Re: Fiesta Subaru 7100 Lomas Blvd. NE
4400 Cutler Ave. NE
Traffic Circulation Layout
Architect's Stamp 4-28-22 (K19-D108A)

Traffic Control Layout Comment Response

TRAFFIC CIRCULATION LAYOUT APPROVED 04/29/2022

D10 GATE DETAILS
1" = 1'-0"

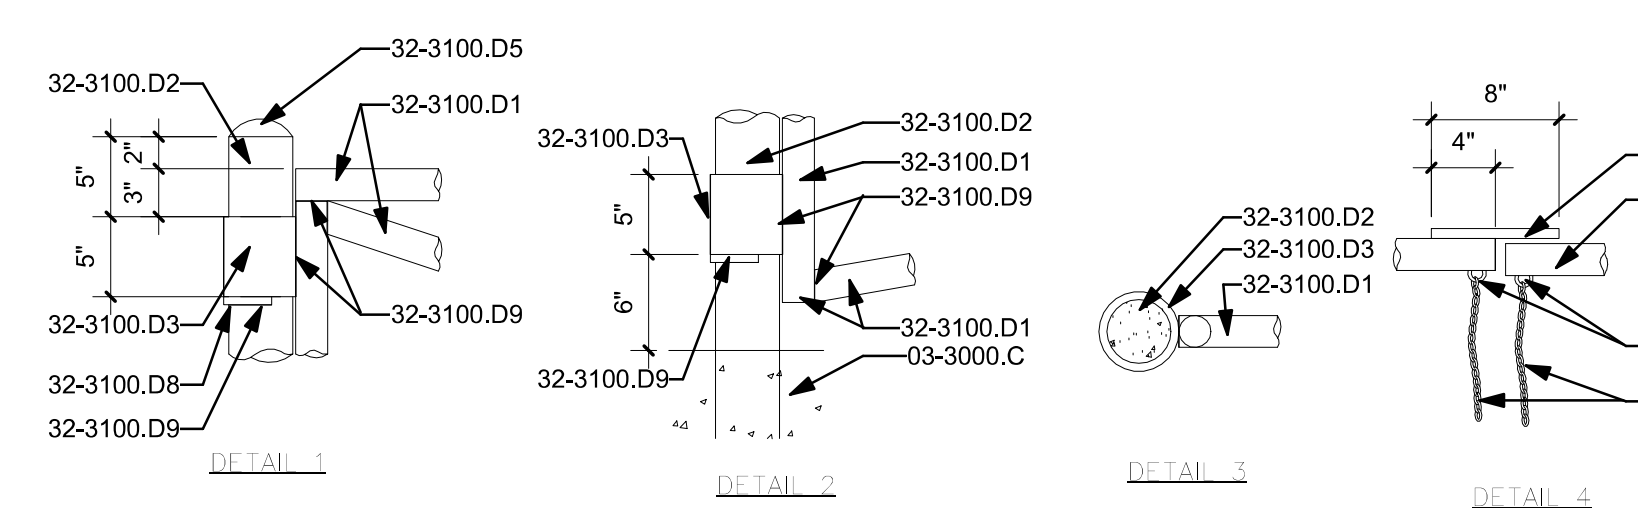
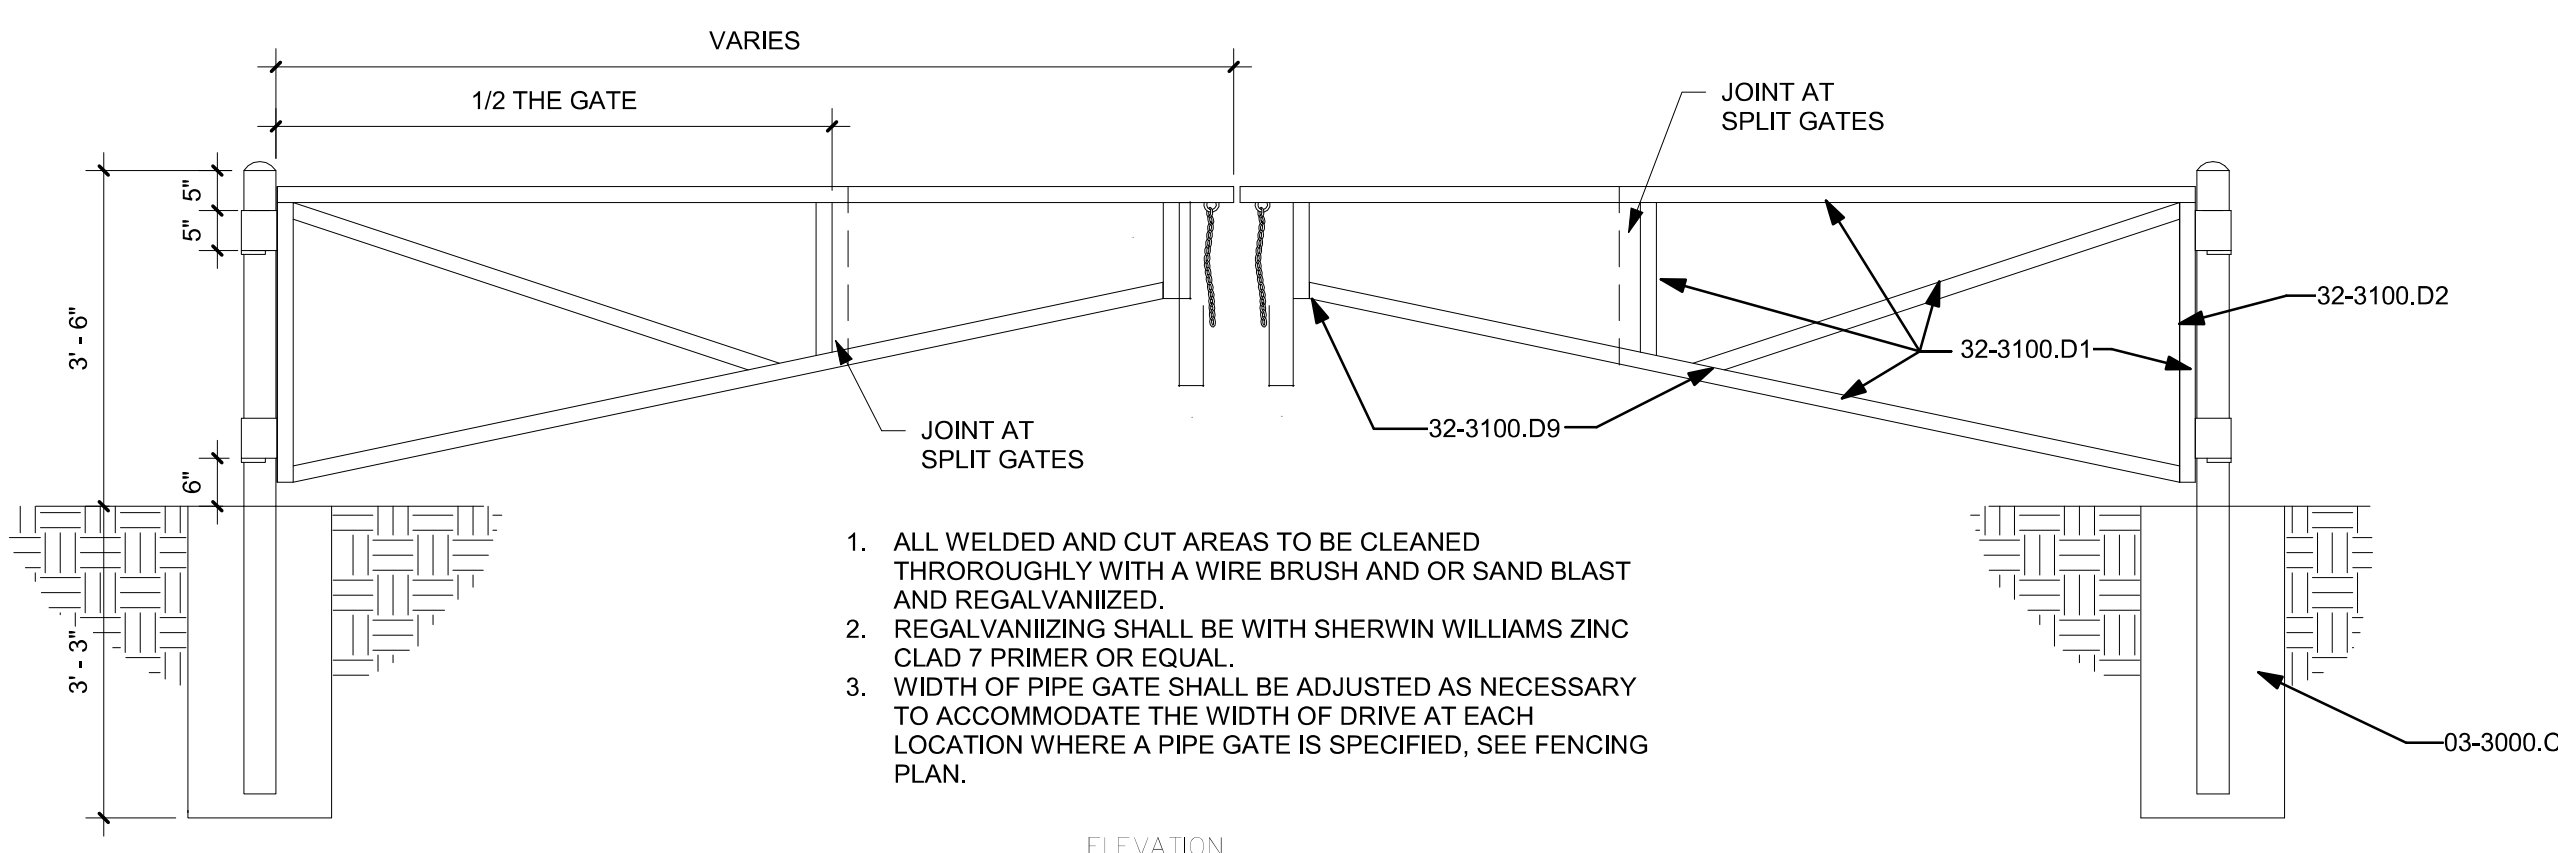
9. Louisiana's, Lomas's and Chama's main access with proposed gates will need a setback of 20 feet to provide turnout.
 - Revised gate design attached.
10. A sidewalk easement will be needed at the corner of Louisiana/Lomas to encompass the full size of new ramp.

SU-30 = Single Unit Truck
Overall Length 30.00ft
Overall Width 8.50ft
Overall Body Height 13.50ft
Max Body Ground Clearance 8.00ft
Lock to Lock 11.00ft
Max Steering Angle (Virtual) 31.80°

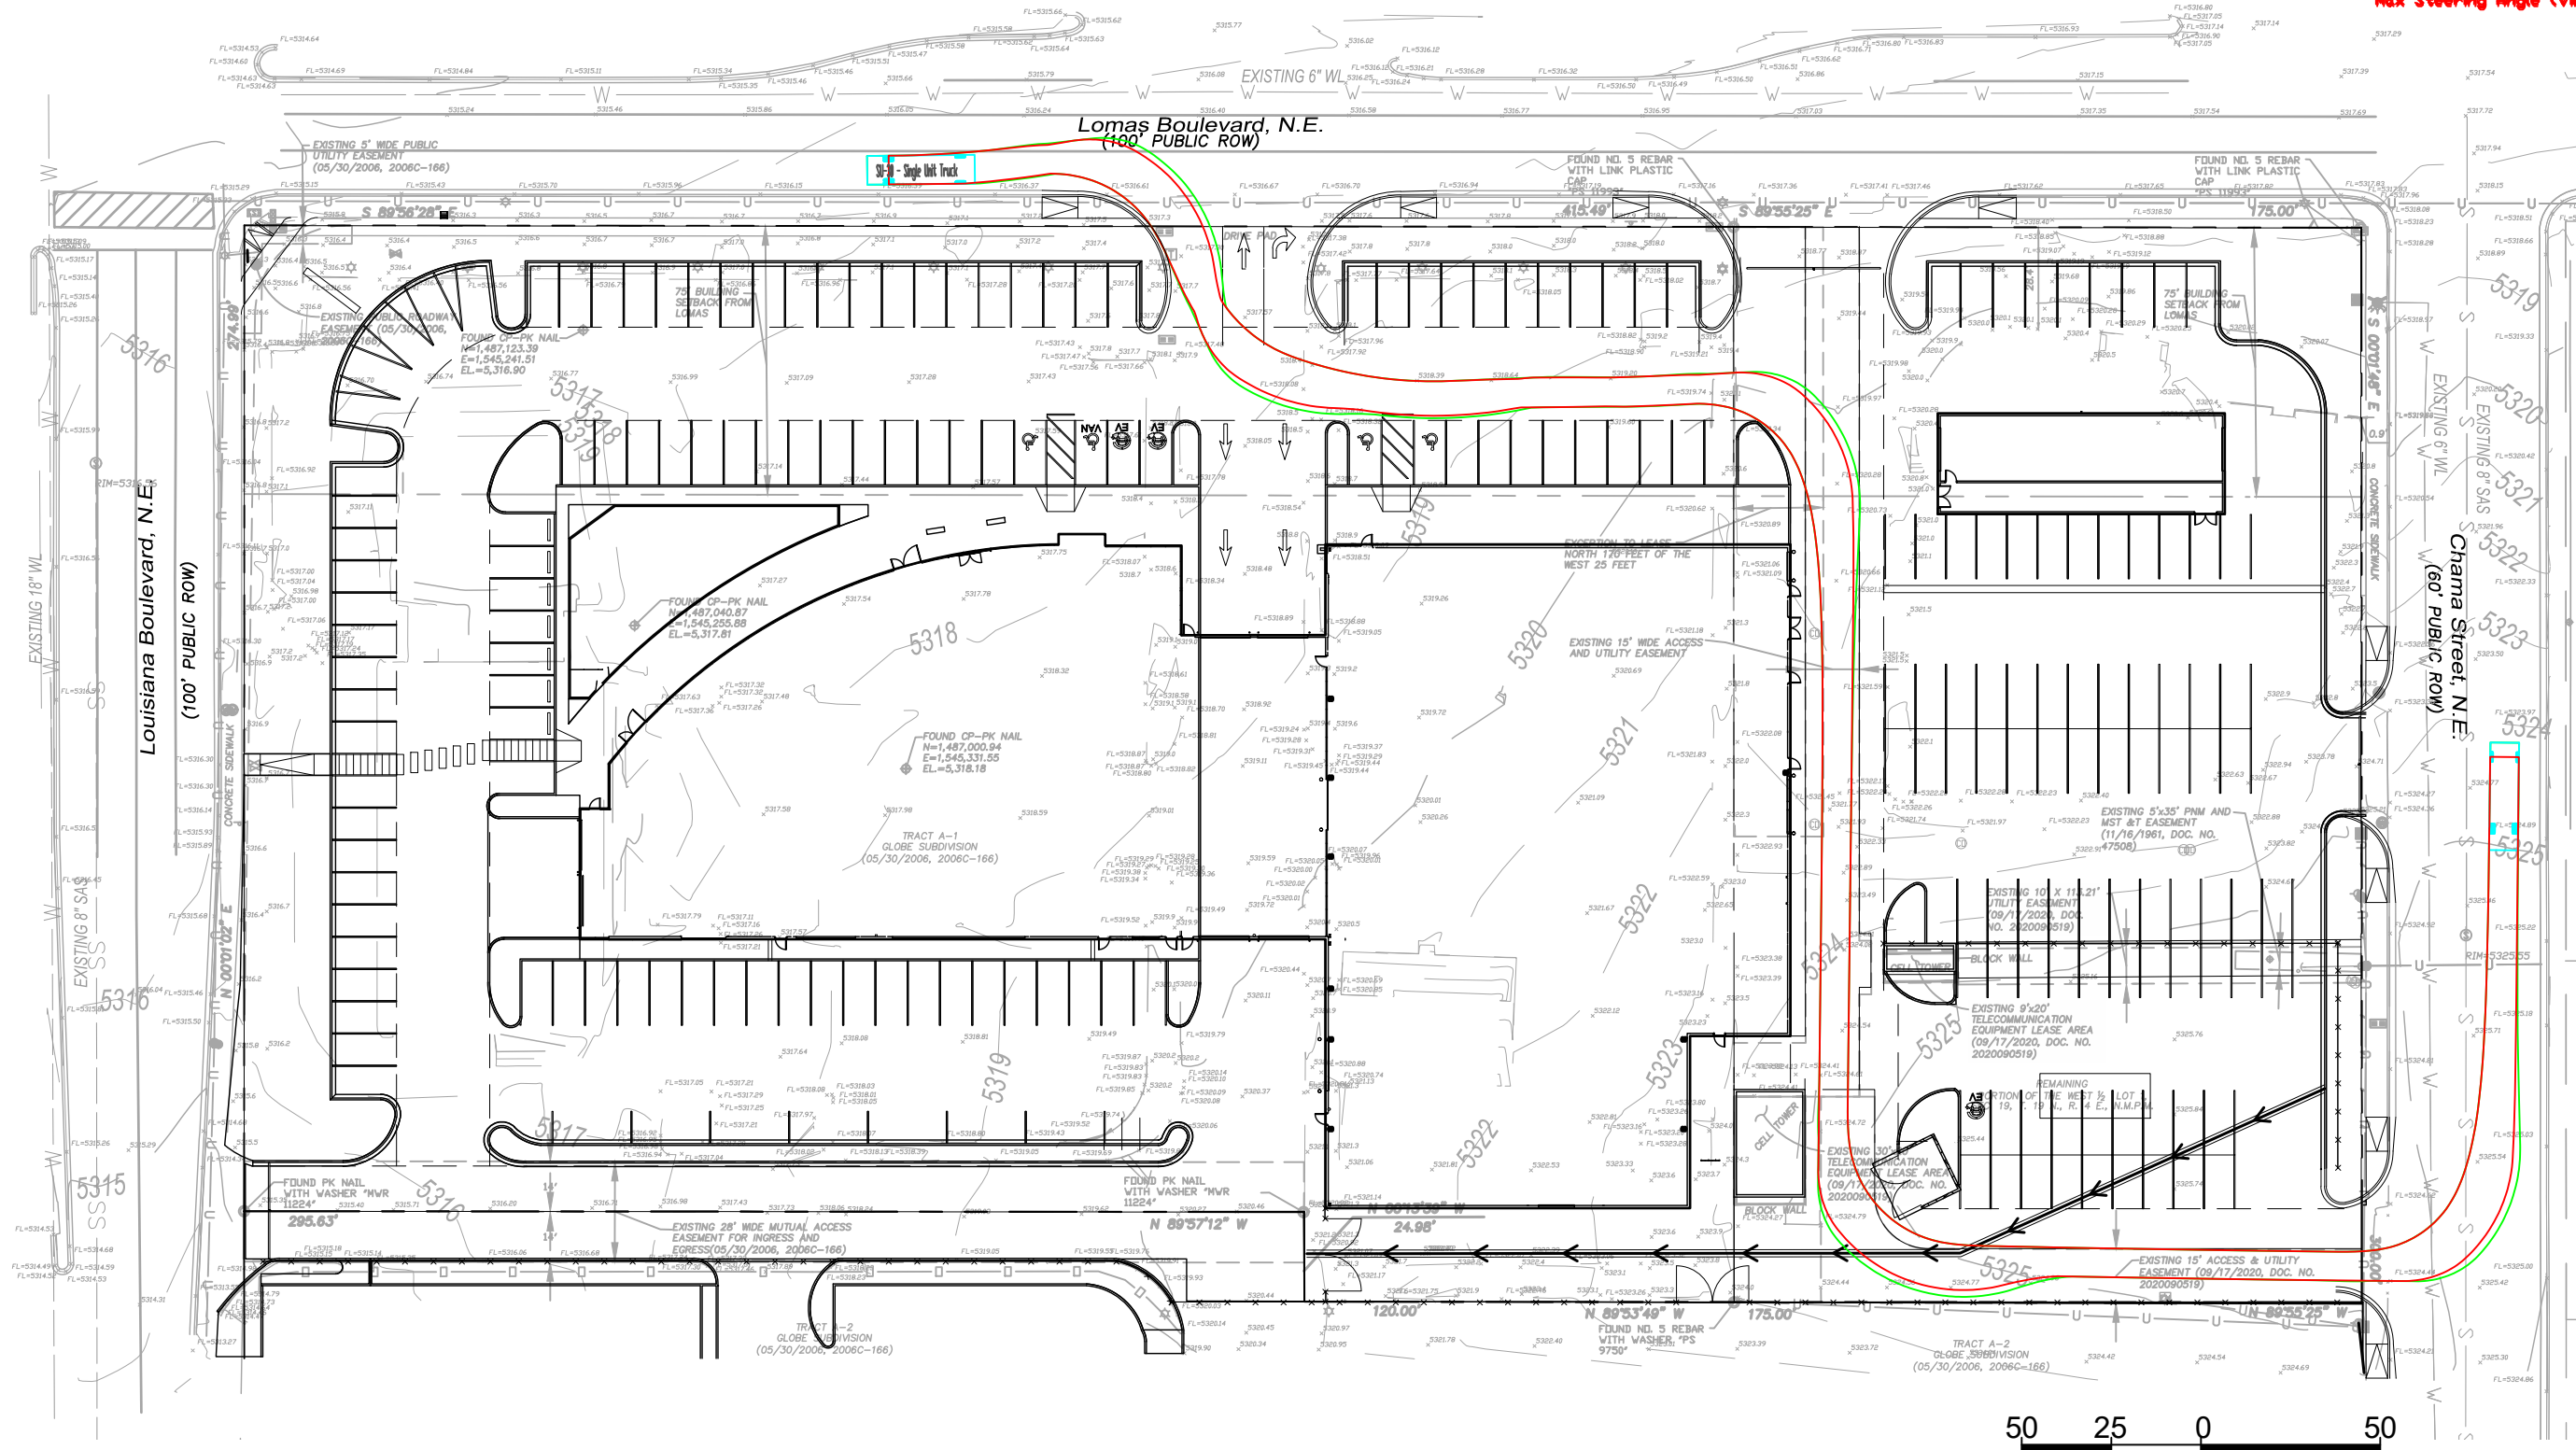
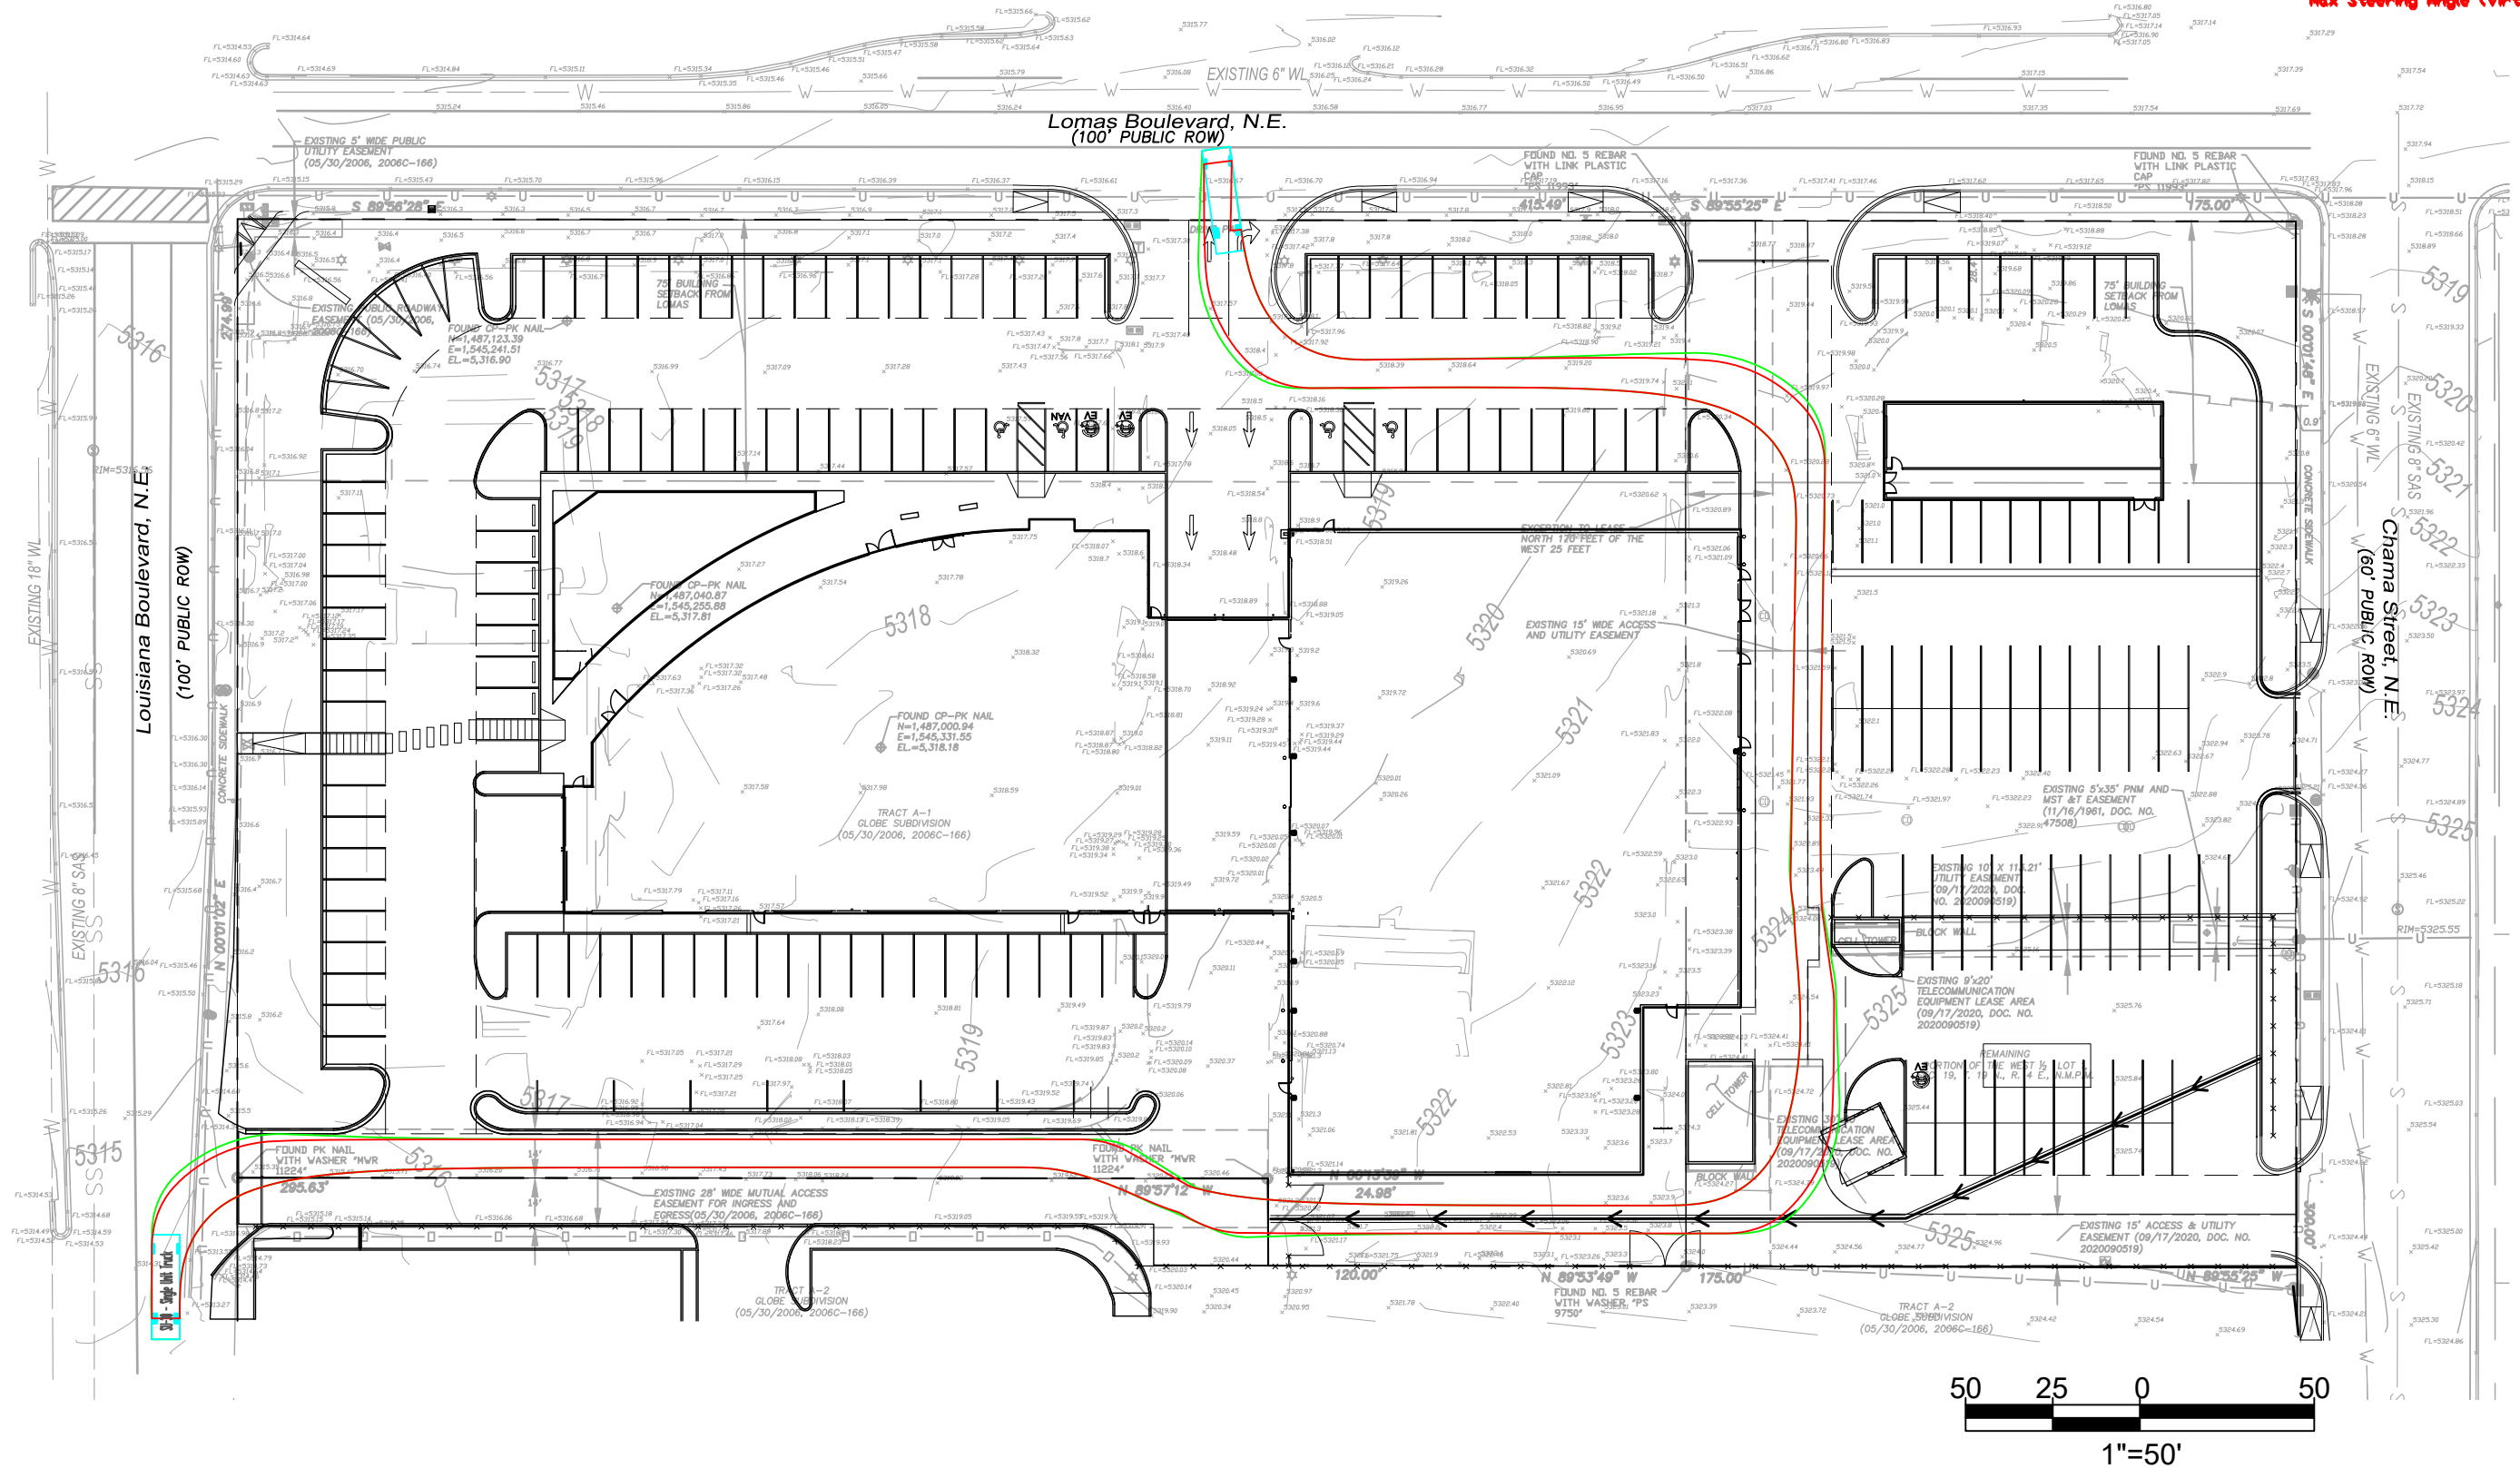
- Sidewalk easement will be provided Precision
11. Provide turning templates for delivery vehicle.

- **Need BHI to provide templates**
